ADDENDUM NO. 02
To Drawings and Specifications dated 02/07/24

Date: FEBRUARY 7, 2024

PROJECT: **Warner Middle School HVAC Upgrade & Modernization**
A#04-121954
Westminster School District

2 FLOOR PLAN - BLDG S-L
1/8" = 1'-0"

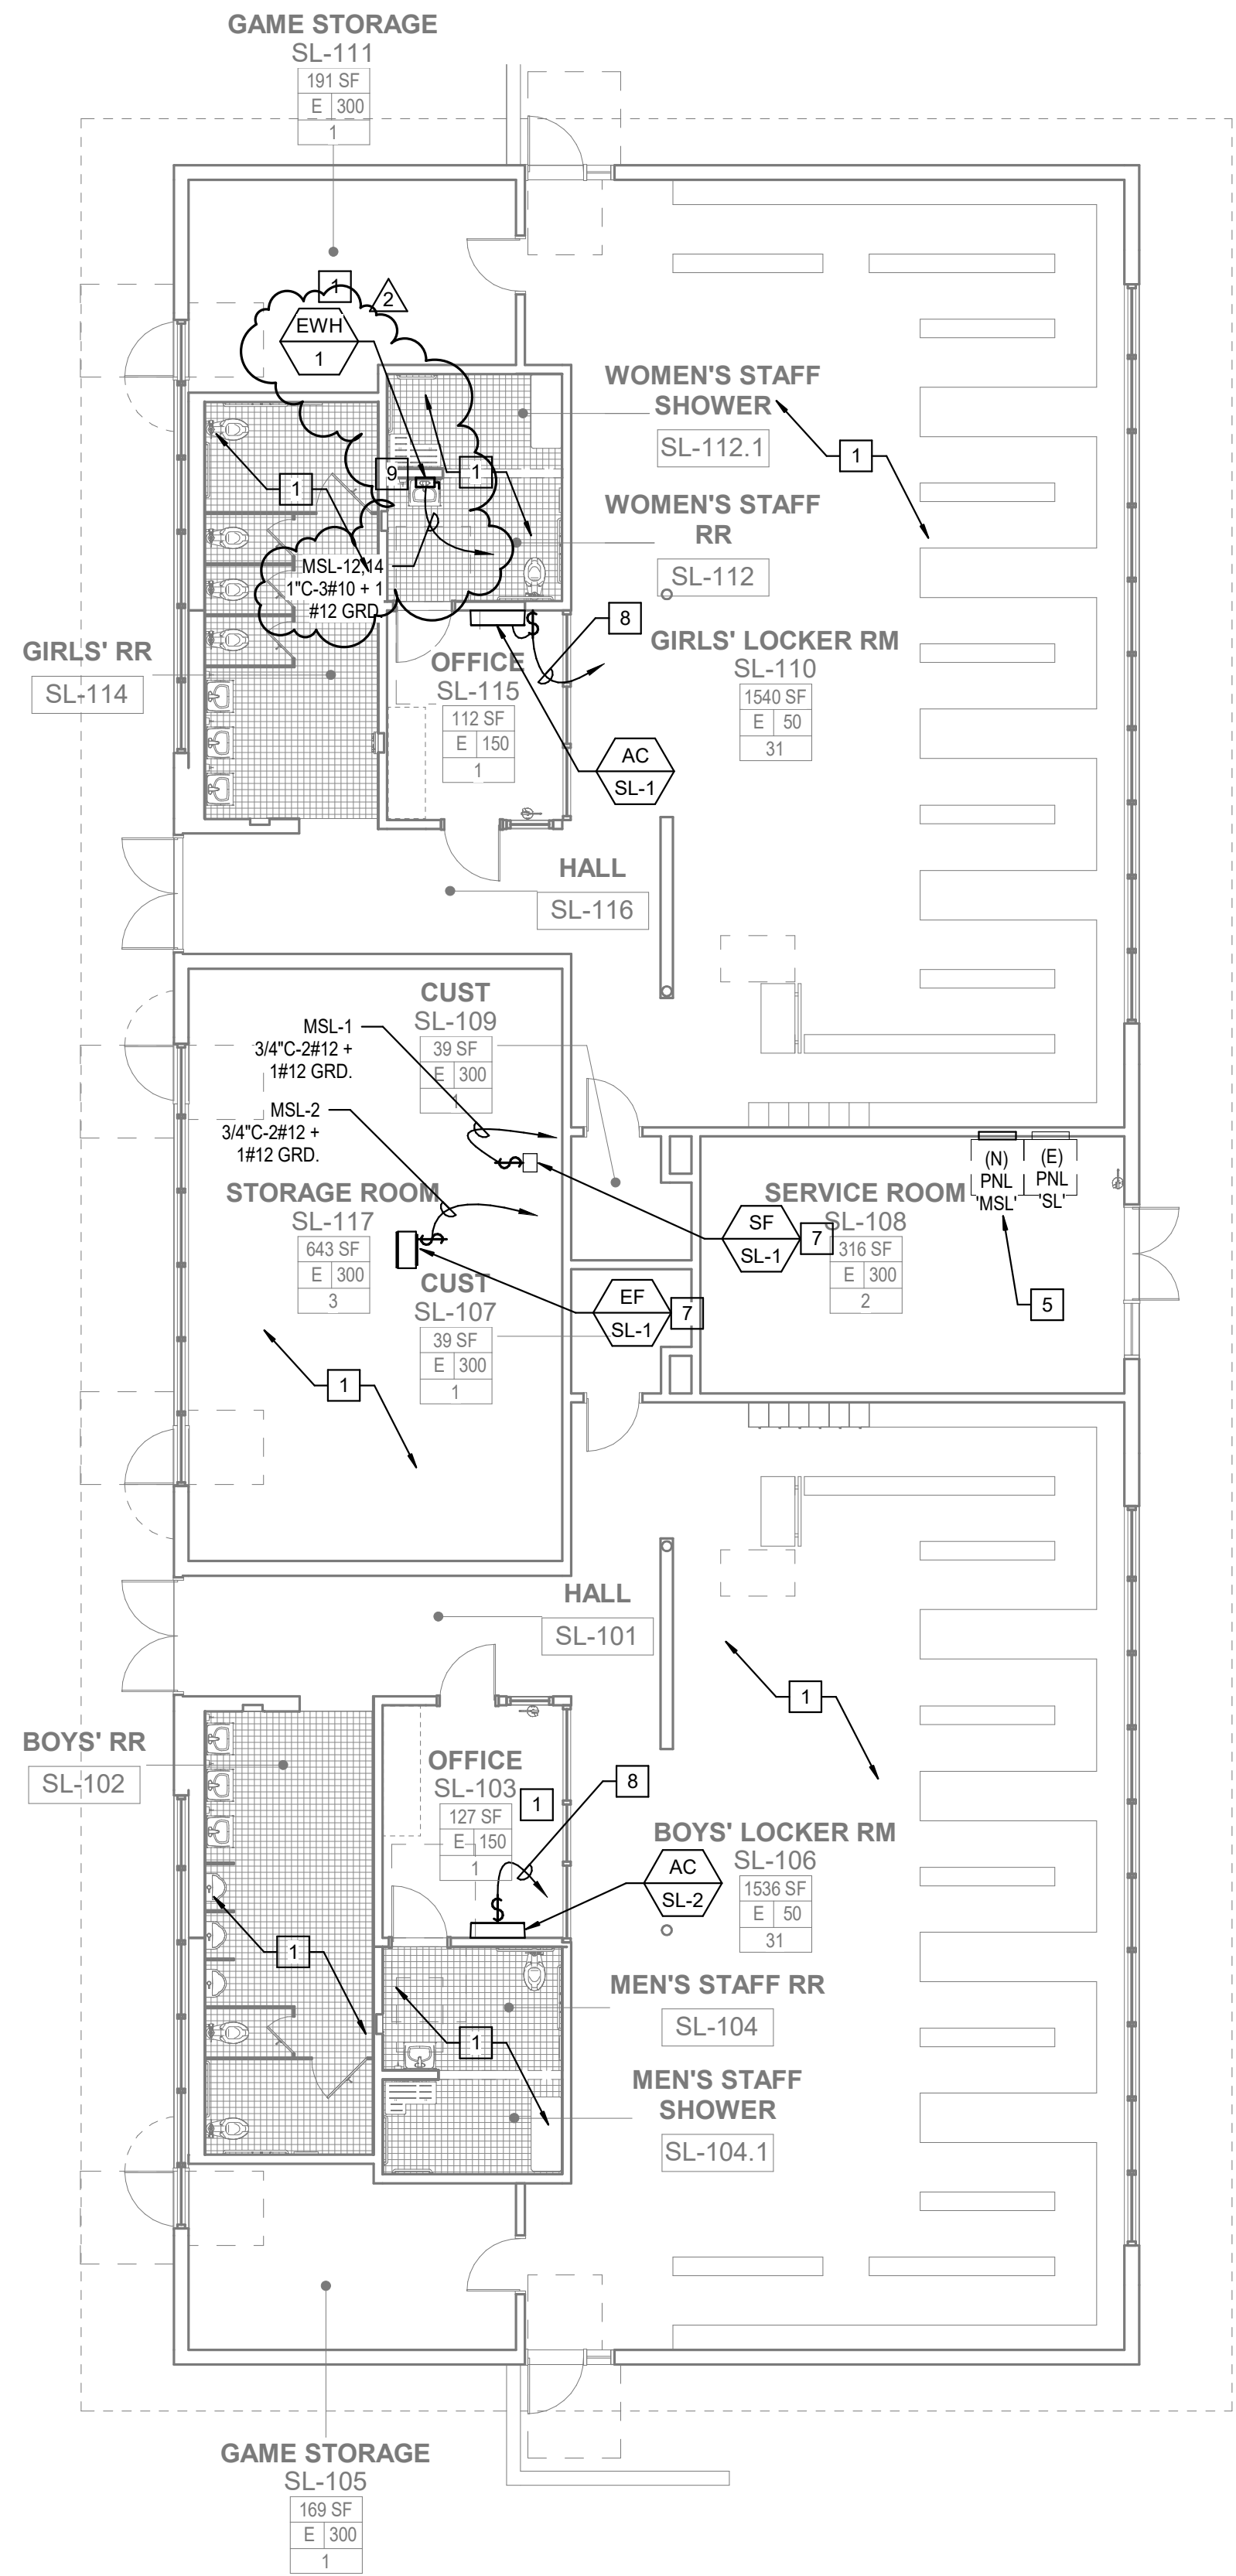
1. Detail 3 – Admin. Bldg.
 - a. Added power for Electric Water Heaters 'EWH-1'
 - b. Added keynote # 9 for water heaters.
2. Detail 2 – Bldg. S-L
 - a. Added power for Electric Water Heater 'EWH-1'
 - b. Added keynote # 9 for water heaters.

3 ROOF PLAN - BLDG C7
1/8" = 1'-0"

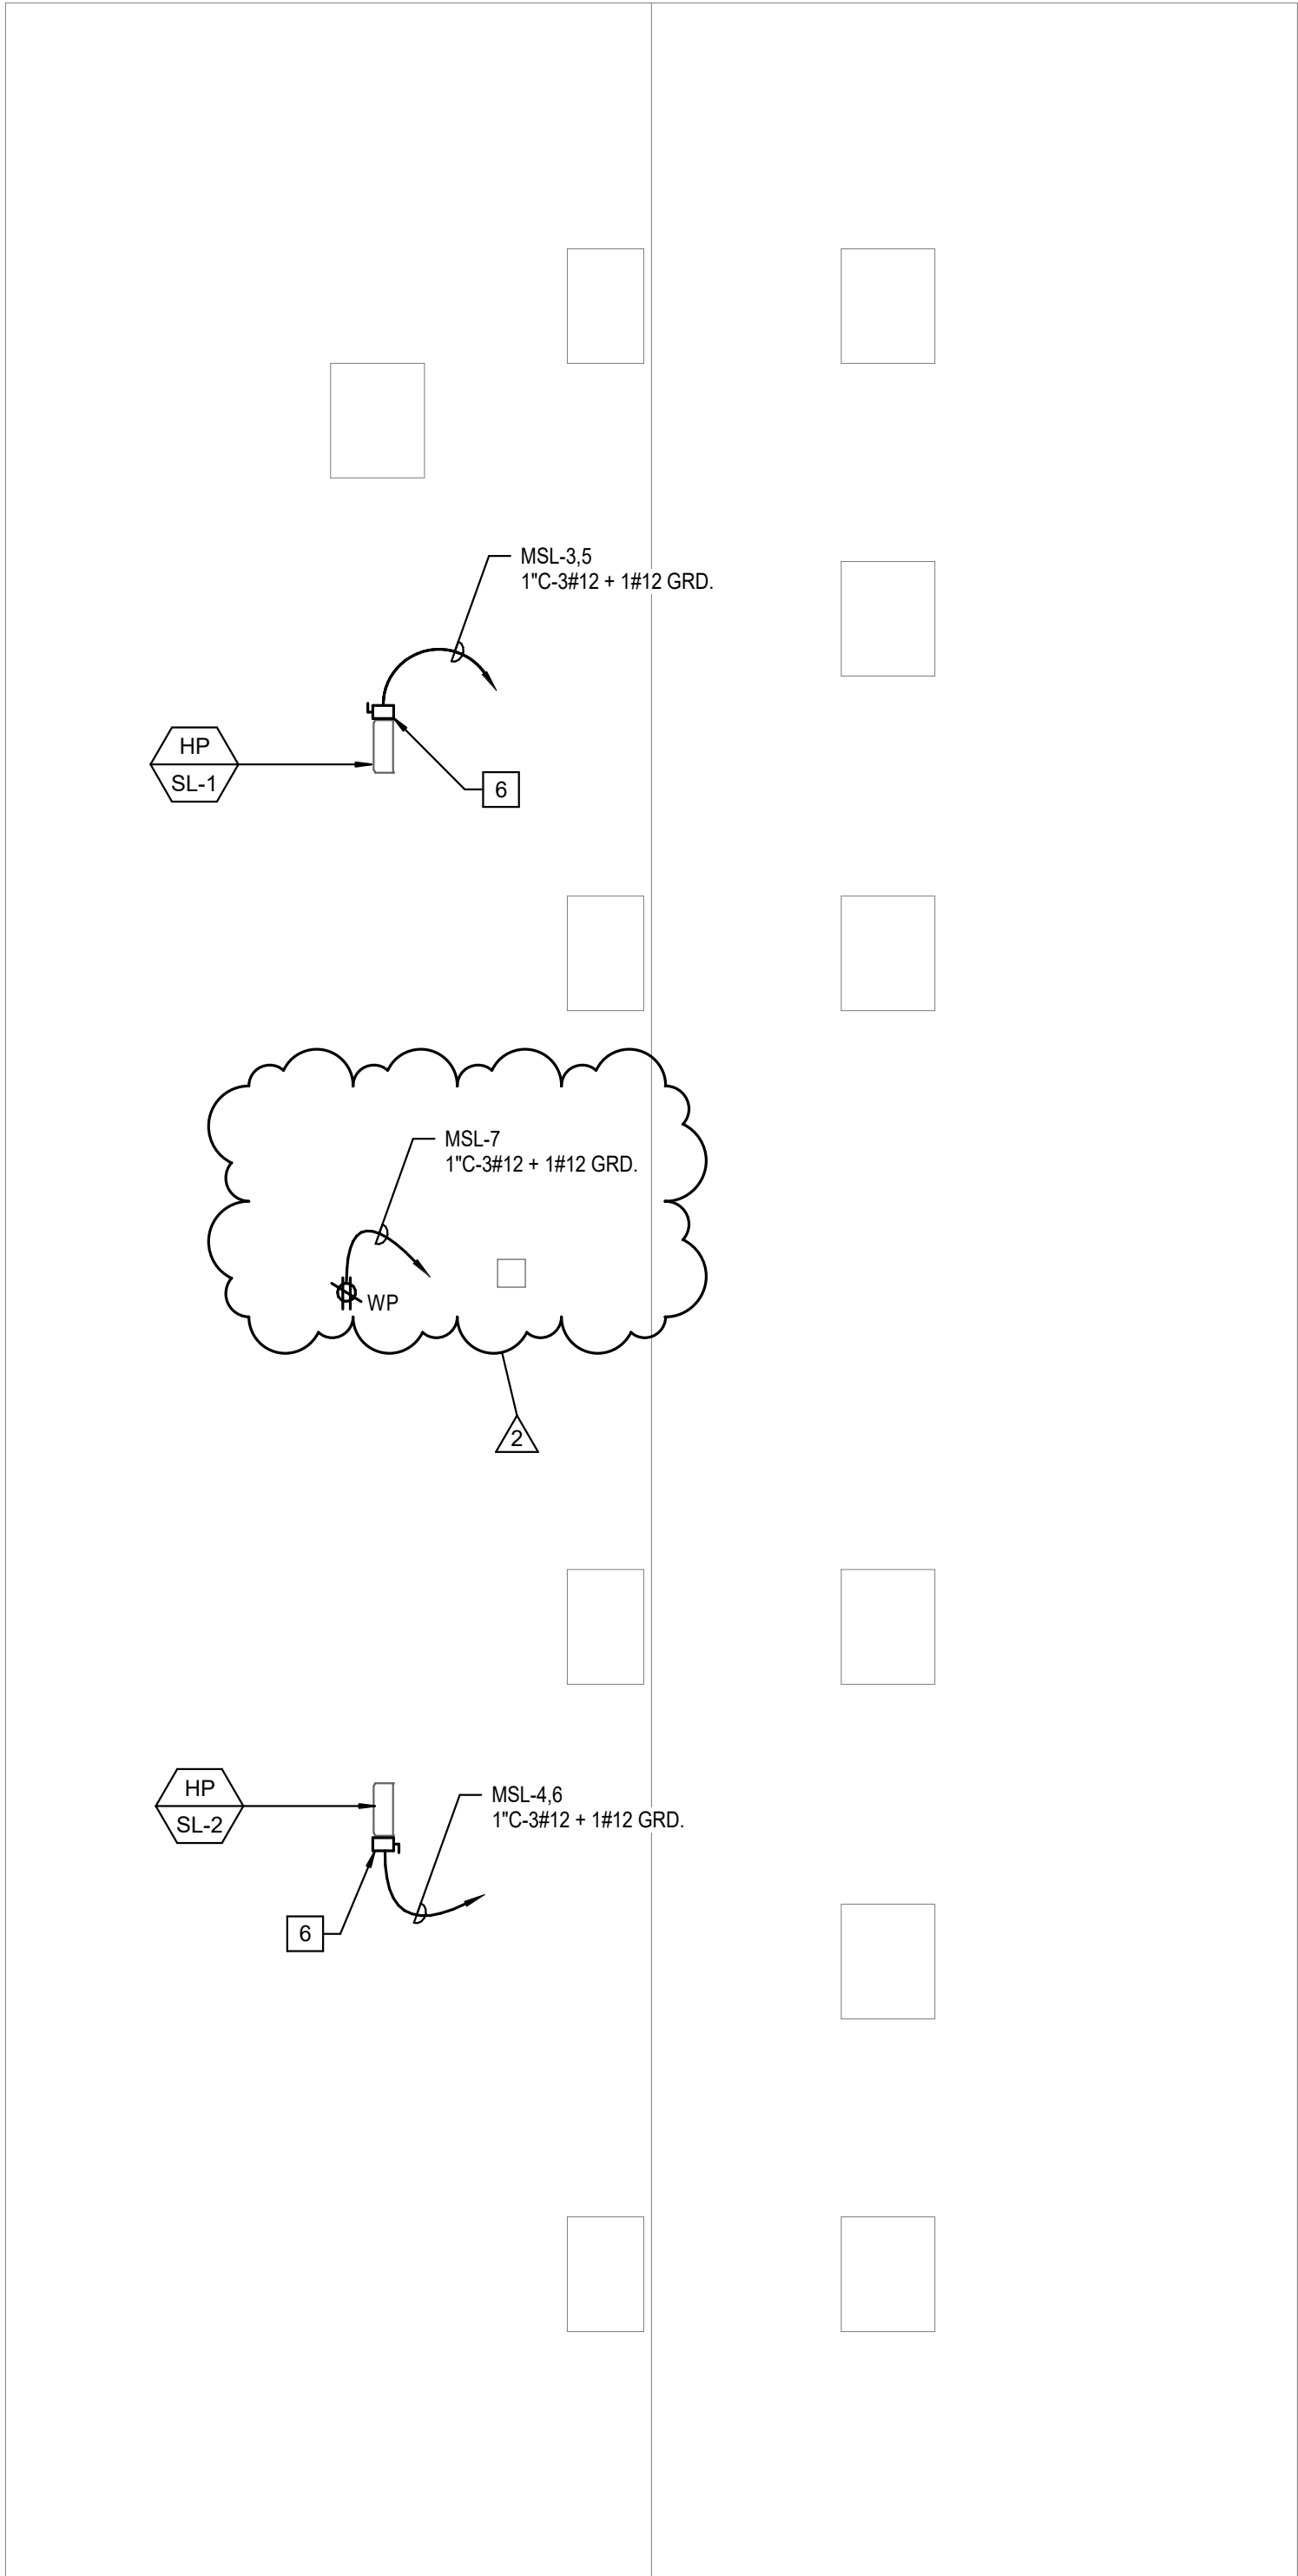
1. Detail "1 – Roof Plan – BLDG C8"
 - a. Revised "Roof Plan – Bldg. C8."
2. Detail "2 – Roof Plan – BLDG S-L"
 - a. Revised "Roof Plan – BLDG S-L."
3. Detail "3 – Roof Plan – BLDG C7"
 - a. Revised "Roof Plan – BLDG C7."

3 ROOF PLAN - BLDG C2
1/8" = 1'-0"

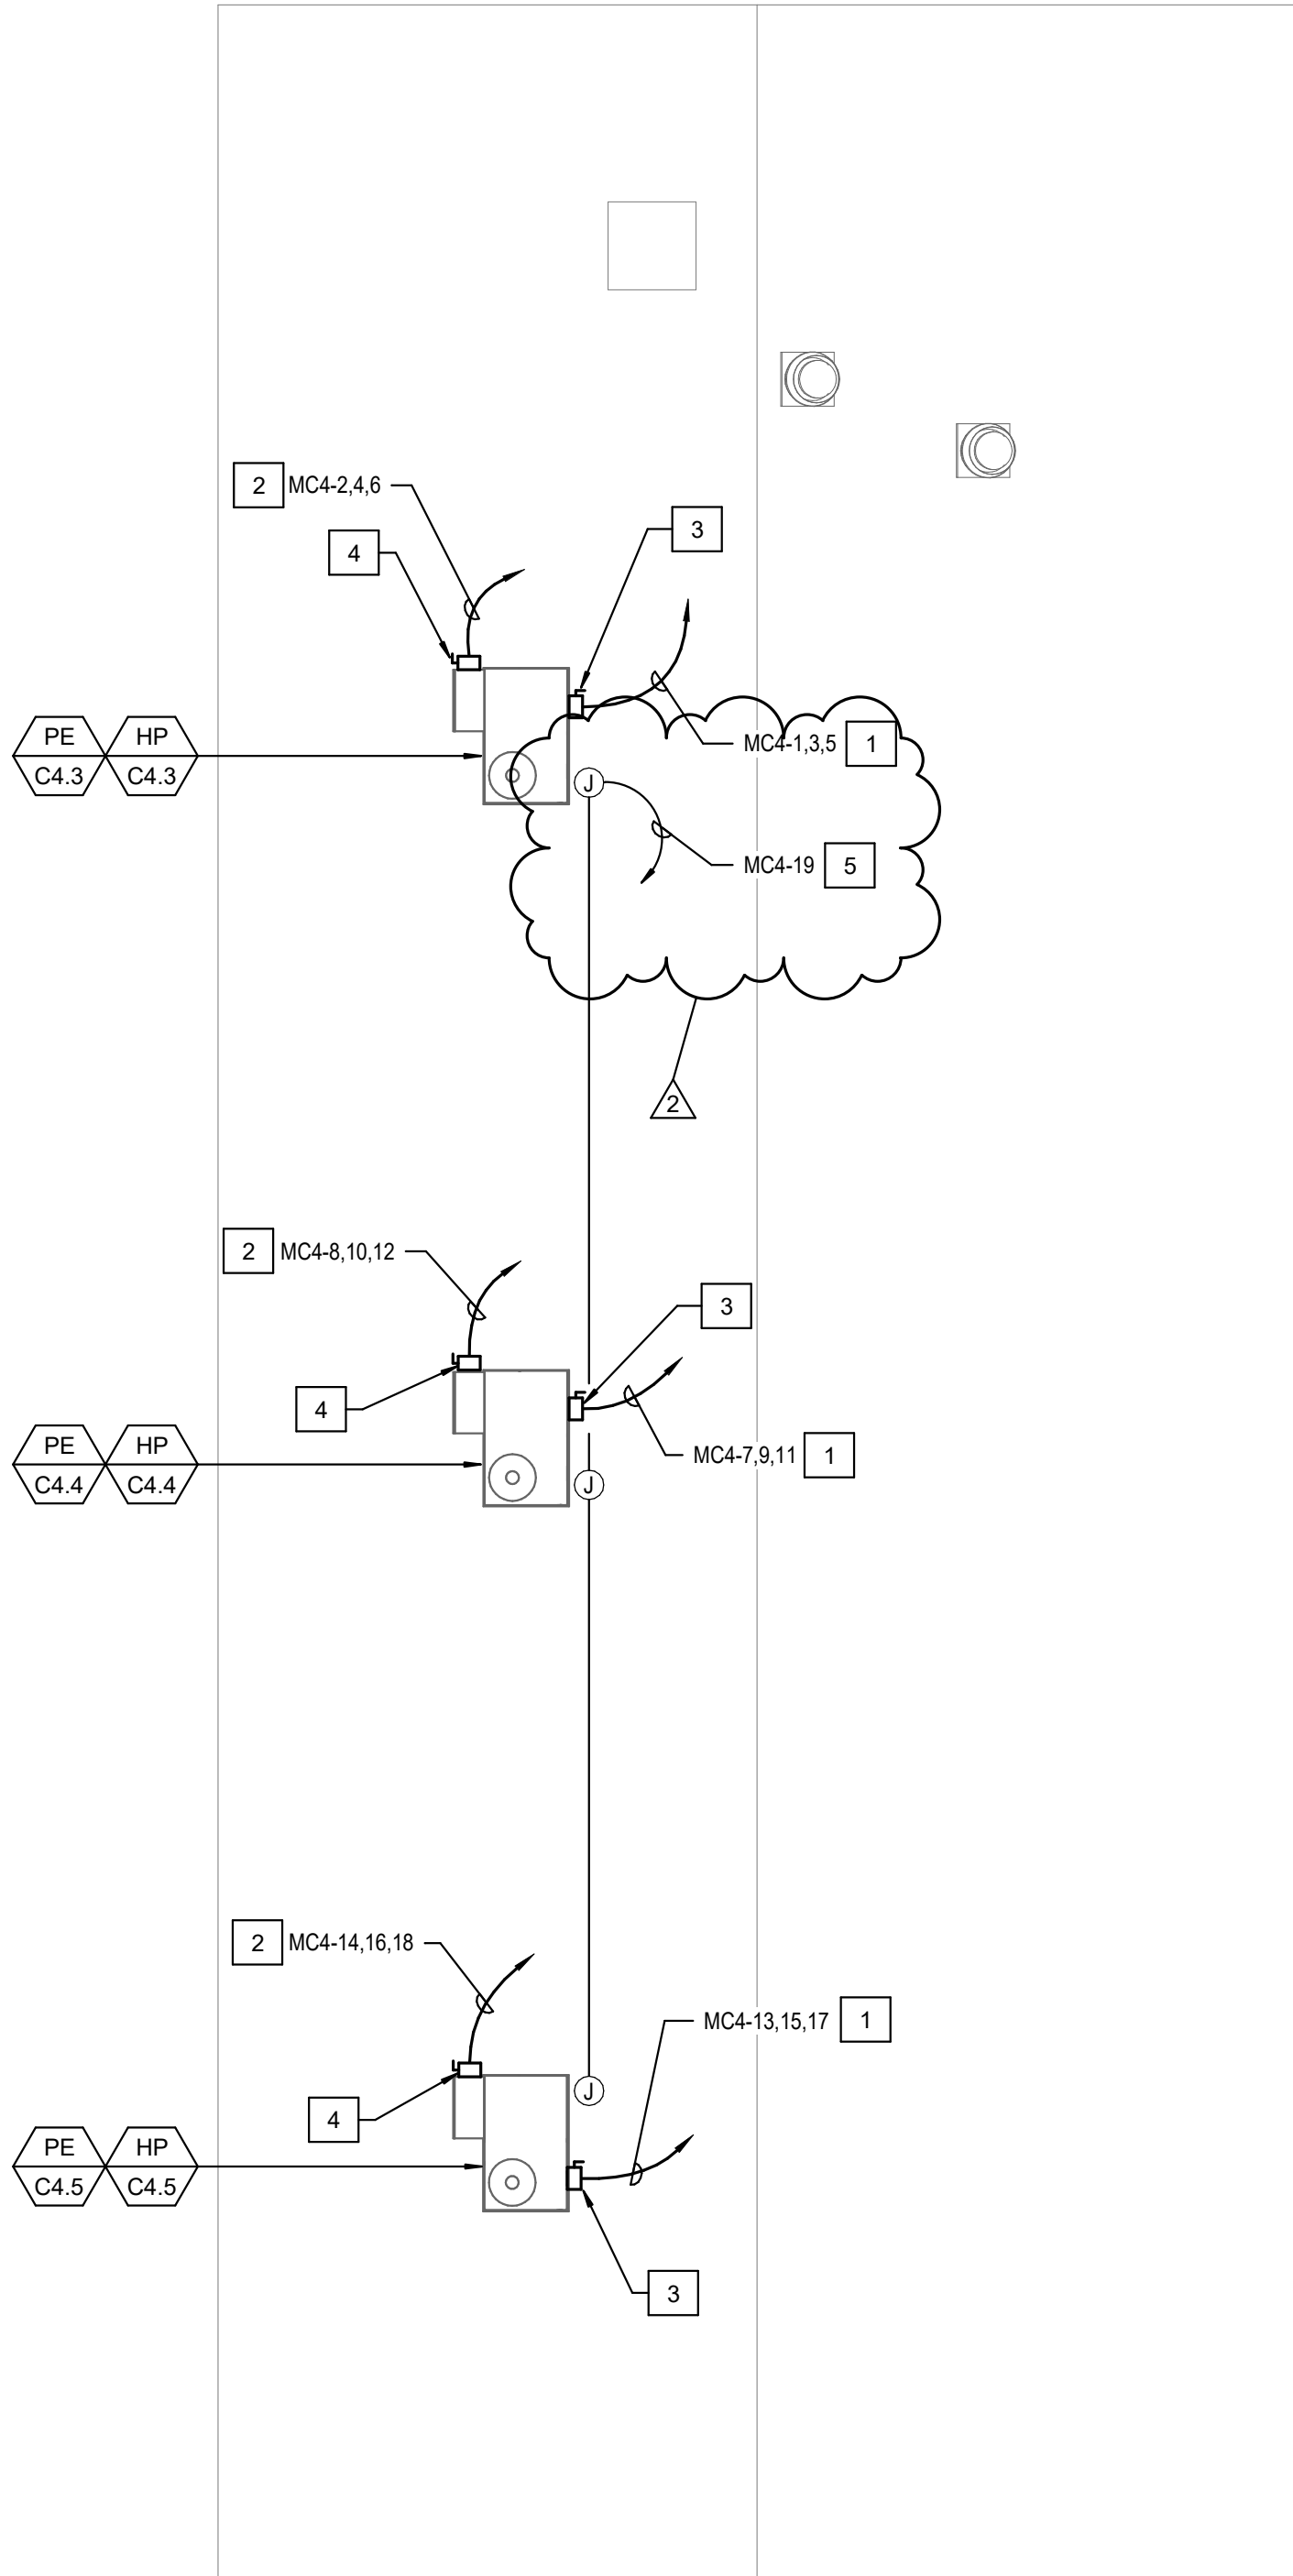
1. Details 1-3
 - a. Added 120V circuits for convenience outlets in rooftop units.
